Rampion 2 Wind Farm Category 8: Examination Documents Change Request Application

Application Reference: 8.97

Subject: **Application for non-material changes to Rampion 2 proposals**

A. Ancient Woodland near Bolney substation

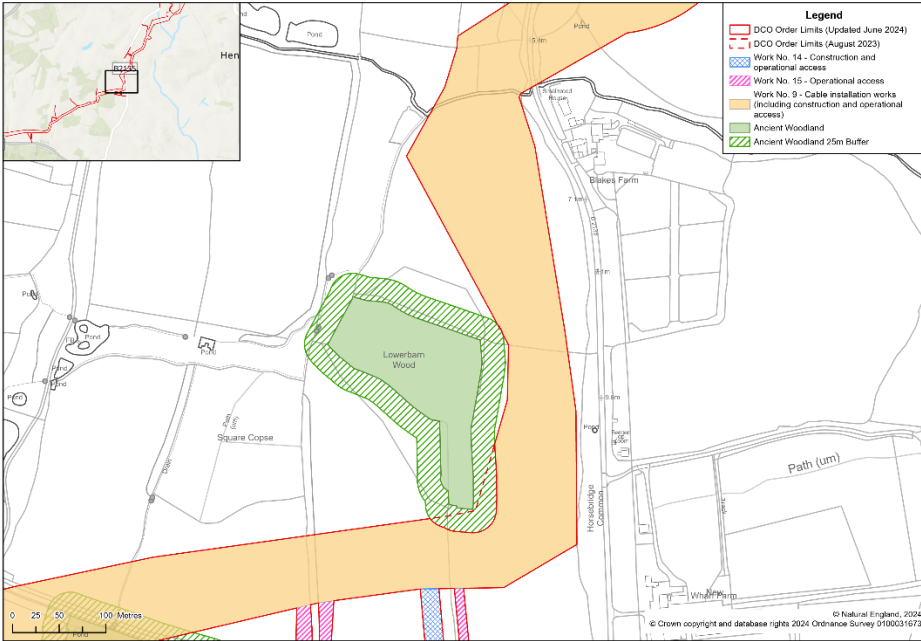
Reference	A
Name	Ancient Woodland near Bolney substation
Location	Works Plan sheet 34 Land plot 34/16
Plan	
Description	A reduction in the Order Limits to exclude 1.0 ha within a 25m buffer of the ancient woodland north of the Bolney National Grid substation. This reduces the extent of land included within Plot 34/16 as shown on the Land Plans.
Rationale	<p>Ancient woodland is protected by policy (NPS EN-1 2024 paragraph 5.4.53, and NPS EN-1 2011 paragraph 5.3.14). The Applicant had applied a 25m avoidance buffer around sites (Commitment C-216, secured in the Code of Construction Practice, secured by DCO Requirement 22) to ensure appropriate protections were in place. However, in light of the ExA's Second Written Questions TE-2.21a, the Applicant has decided to remove this section of land from the Order limits to reinforce this avoidance and to ensure that no land rights are imposed over this area.</p> <p>Given the existing avoidance commitment, this would not result in a change of impacts from the submitted application, but in making this change the Applicant seeks to demonstrate their commitment to minimising environmental impacts, and to only seeking consent, and land rights, for the minimum area required to deliver the project.</p>

There remains sufficient flexibility within the Order limits at this location for the installation of the underground cable.
Compulsory Acquisition	The Applicant considers that the Compulsory Acquisition Regulations 2010 are not engaged in this scenario. The procedure prescribed by the Regulations applies when there is a proposal to include 'additional land' (Reg 4). As this change would result in removal, rather than addition, of land from the Order limits, the CA Regulations are not engaged.
Environmental effects	This change would not result in any new or different environmental effects. As the area considered for removal was already subject to a commitment restricting construction use, there would be no change in impacts as a result of its removal. The cable installation assessed in the Environmental Statement would still occur as assessed, with the corridor located within the remaining Order limits. There would be no change to the area of land affected by the cable corridor, or any vegetation affected.

C. Ancient Woodland (Lowerbarn Wood) on Sweethill Farm

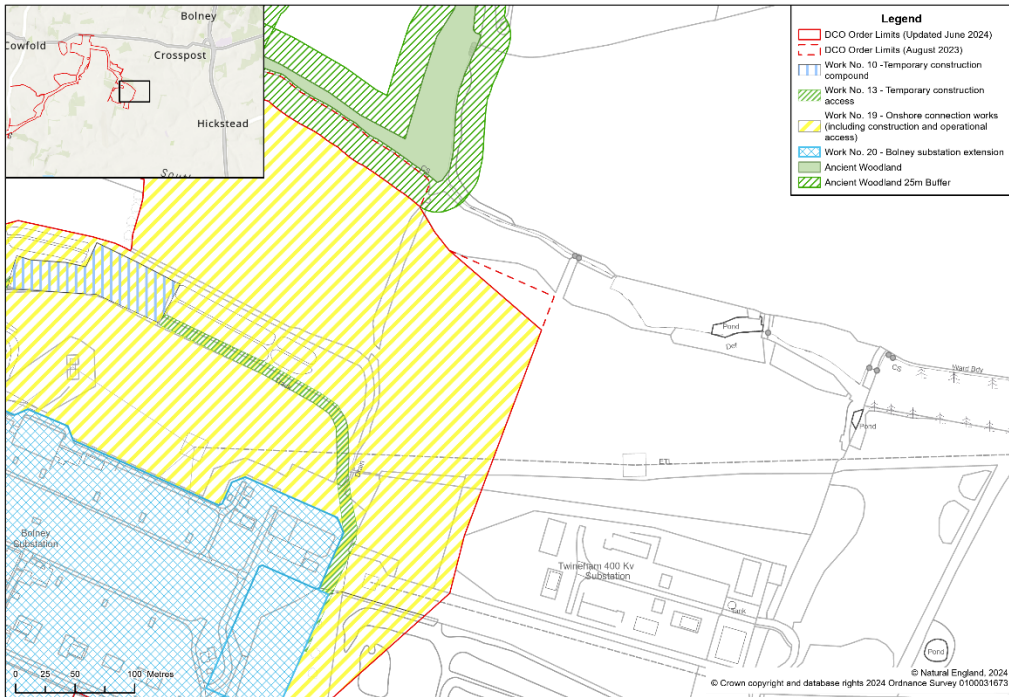
Reference	C
Name	Ancient Woodland on Sweethill Farm
Location	Works Plan sheet 26 Land plot 26/3
Plan	
Description	A reduction in the Order Limits to exclude 0.20ha within a 25m buffer of the ancient woodland, known as Lowerbarn Wood, on Sweethill Farm. This amendment would reduce the extent of land included within Plot 26/3 of the Land Plans.
Rationale	<p>Ancient woodland is protected by policy (NPS EN-1 2024 paragraph 5.4.53, and NPS EN-1 2011 paragraph 5.3.14). The Applicant had applied a 25m avoidance buffer around sites (Commitment C-216, secured in the Code of Construction Practice secured by DCO Requirement 22) to ensure appropriate protections were in place. However, in light of the ExA's Second Written Questions TE-2.21c, the Applicant has decided to remove this section of land from the Order limits to reinforce this avoidance and to ensure that no land rights are imposed over this area.</p> <p>Given the existing avoidance commitment, this would not result in a change of impacts from the submitted application, but in making this change the Applicant seeks to demonstrate their commitment to minimising environmental impacts, and only seeking consent, and land rights, for the minimum area required to deliver the project.</p>

There remains sufficient flexibility within the Order limits at this location for the installation of the underground cable.
Compulsory Acquisition	The Applicant considers that the Compulsory Acquisition Regulations 2010 are not engaged in this scenario. The procedure prescribed by the Regulations applies when there is a proposal to include 'additional land' (Reg 4). As this change would result in removal, rather than addition, of land from the Order limits, the CA Regulations are not engaged.
Environmental effects	This change would not result in any new or different environmental effects. As the area considered for removal was already subject to a commitment restricting construction use, there would be no change in impacts as a result of its removal. The cable installation assessed in the Environmental Statement would still occur as assessed, with the corridor located within the remaining Order limits. There would be no change to the area of land affected by the cable corridor, or any vegetation affected.

D. Ancient Woodland near Michelgrove

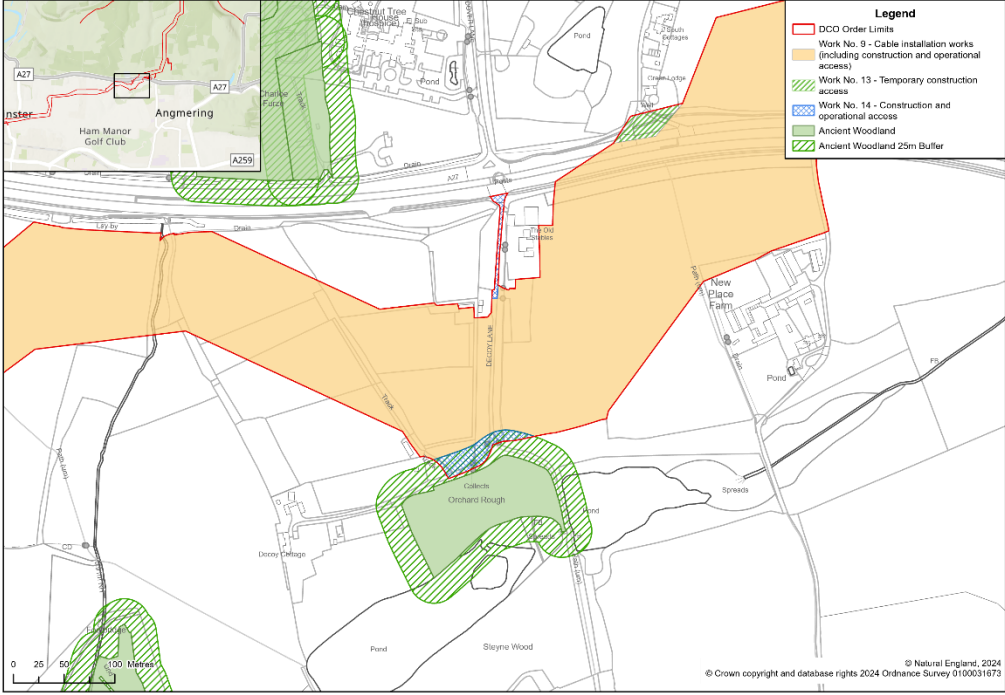
Reference	D
Name	Ancient Woodland near Michelgrove
Location	Works Plan sheet 8 Land plot 8/4
Plan	 <p>The map displays the project area with various zones and boundaries. Key features include: <ul style="list-style-type: none"> DCO Order Limits: Updated June 2024 (solid red line) and August 2023 (dashed red line). Work Areas: Work No. 13 - Temporary construction access (green hatched), Work No. 14 - Construction and operational access (blue hatched), Work No. 15 - Operational access (pink hatched), and Work No. 9 - Cable installation works (including construction and operational access) (orange). Woodland and Buffers: Ancient Woodland (green) and Ancient Woodland 25m Buffer (green hatched). Geographic Labels: Michelgrove Park, The Buckmans, Barnstake Copse, Patching Rough, Storyland Copse, Sargons Farm, and Angmering Park. Inset Map: Shows the location relative to Arundel, Findon, and Lymington. Scale: 0, 50, 100, 200 Metres. </p>

Description	A reduction in the Order Limits to exclude 0.55ha within a 25m buffer of the ancient woodland east of Angmering Park Farm and south of Michelgrove. This amendment would reduce the extent of land included within Land Plot 8/4 of the Land Plans.
Rationale	<p>Ancient woodland is protected by policy (NPS EN-1 2024 paragraph 5.4.53, and NPS EN-1 2011 paragraph 5.3.14). The Applicant had applied a 25m avoidance buffer around sites (Commitment C-216, secured in the Code of Construction Practice secured by DCO Requirement 22) to ensure appropriate protections were in place. However, in light of the ExA's Second Written Questions TE-2.21d, the Applicant has decided to remove this section of land from the Order limits to reinforce this avoidance and to ensure that no land rights are imposed over this area.</p> <p>Given the existing avoidance commitment, this would not result in a change of impacts from the submitted application, but in making this change the Applicant seeks to demonstrate their commitment to minimising environmental impacts, and only seeking consent, and land rights, for the minimum area required to deliver the project.</p> <p>There remains sufficient flexibility within the Order limits at this location for the installation of the underground cable.</p>

E. Ancleggan Land

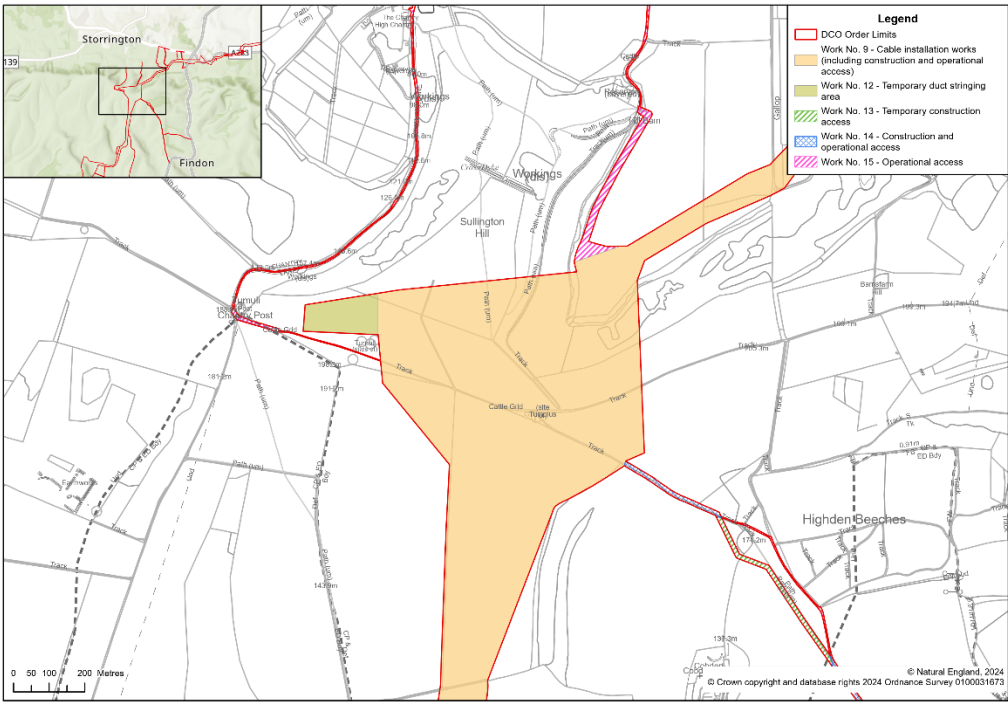
Reference	E
Name	Ancleggan Land
Location	Works Plan sheet 34 Land plot 34/19 and plot 34/23
Plan	
Description	<p>A reduction in the Order Limits of 0.14ha to exclude the far easternmost corner of the land affected, north east of the National Grid substation at Bolney. The amendment would result in a reduced extent of land included within Plot 34/19 shown on the Land Plans.</p> <p>Whilst not a change to the land within Order Limits or on the Land Plans, the Applicant has noted a drafting error in Schedule 7 to the draft Order affecting Plot 34/23. This parcel is required for Cable Rights and Cable Restrictive Covenants for the purposes of Work 19, as explained in Appendix 1 to the Statement of Reasons [PEPD-012] and in its responses to the Affected Parties' representations [Table LI45.1 in the Applicant's response to Mr Worsley's Relevant Representations REP1-017].</p> <p>It has come to the Applicant's attention that Plot 34/23 was mistakenly omitted from the list of parcels noted against the Cable Restrictive Covenant package in Schedule 7 to the draft Order, with Plot 34/31 having been duplicated instead. This drafting error has been corrected by the Applicant.</p>

Rationale	Due to a number of factors including extensive buried services to the south and uncertainty around protective provision requirements associated with those, together

<p>with uncertainty over the proposed future land uses in this area, the Applicant requires flexibility within the Order limits in which to locate the cable corridor. However, the interested party considers the flexibility to be too great. The Applicant has reviewed the area affected and considers that it is able to slightly reduce the extent of the Order limits, but that any reduction beyond this at this stage could prejudice the installation of the cable.</p> <p>In making this change the Applicant seeks to demonstrate that they are only seeking consent, and land rights, for the minimum area required to deliver the project.</p>
Compulsory Acquisition	<p>The Applicant considers that the Compulsory Acquisition Regulations 2010 are not engaged in this scenario. The procedure prescribed by the Regulations applies when there is a proposal to include 'additional land' (Reg 4). As this change would result in removal, rather than addition, of land from the Order limits, the CA Regulations are not engaged.</p>

F. Ancient Woodland (Steyne Wood) near Decoy Lane

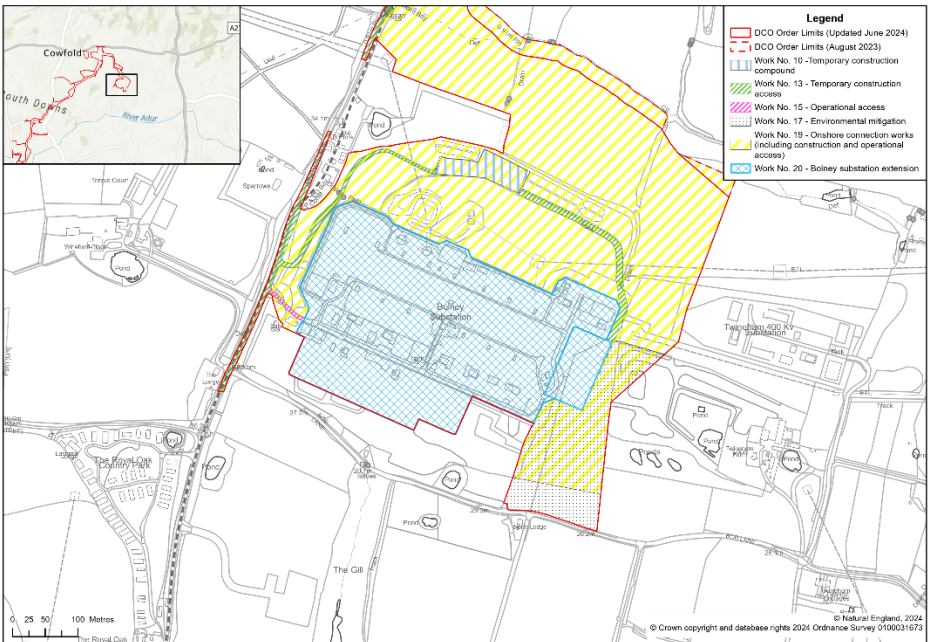
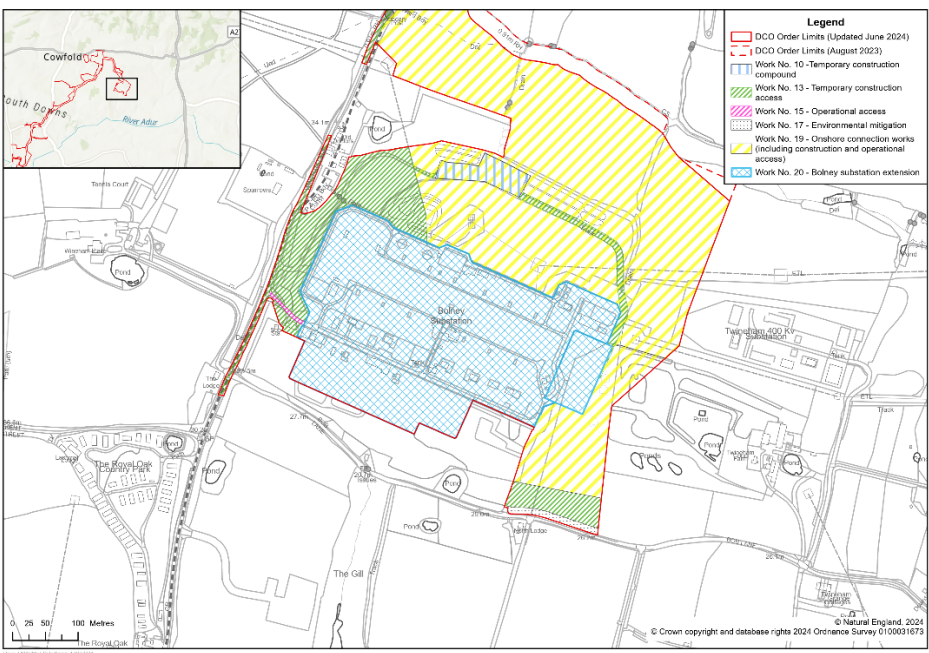
Reference	F
Name	Ancient Woodland near Decoy Lane
Location	Works Plan sheet 7 Land plot 7/1
Plan	
Description	<p>A reduced scope of works within a 25m buffer of the ancient woodland south of Decoy Lane, changing from Work 9 Cable Installation to Work 14 Construction and Operational Access. This amendment would reduce the extent of land included in Plot 7/1 as shown on the Land Plans. Plot 7/ 1 is also sub-divided to create a new plot 7/36 over which a lesser rights package for Construction and Operational Access is now sought.</p>
Rationale	<p>Ancient woodland is protected by policy (NPS EN-1 2024 paragraph 5.4.53, and NPS EN-1 2011 paragraph 5.3.14). The Applicant had applied a 25m avoidance buffer around sites (Commitment C-216, secured in the Code of Construction Practice secured by DCO Requirement 22) to ensure appropriate protections were in place. However, in light of the ExA’s Second Written Questions TE-2.21e, the Applicant has reviewed the scope of works that apply in this area.</p> <p>The affected area would be used for light construction access, and subsequently for operational access, making use of existing gateways on Decoy Lane. This usage would have been permitted under Work 9, but is more precisely defined by Work 14. The use</p>

<p>of existing tracks (Decoy Lane and tracks off it) is in accordance with Commitment C-216.</p> <p>Given the existing avoidance commitment, this would not result in a change of impacts from the submitted application, but in making this change the Applicant seeks to demonstrate their commitment to minimising environmental impacts, and only seeking consent and land rights for the minimum area required to deliver the project.</p>
Compulsory Acquisition	<p>The Applicant considers that the Compulsory Acquisition Regulations 2010 are not engaged in this scenario. The procedure prescribed by the Regulations applies when there is a proposal to include 'additional land' (Reg 4). As this change would result in a lesser class of land right sought (from the Cable Rights and Cable Restrictive Covenant package, to the Construction and Operational Access Rights package), rather than addition of land to the Order limits, the CA Regulations are not engaged.</p>
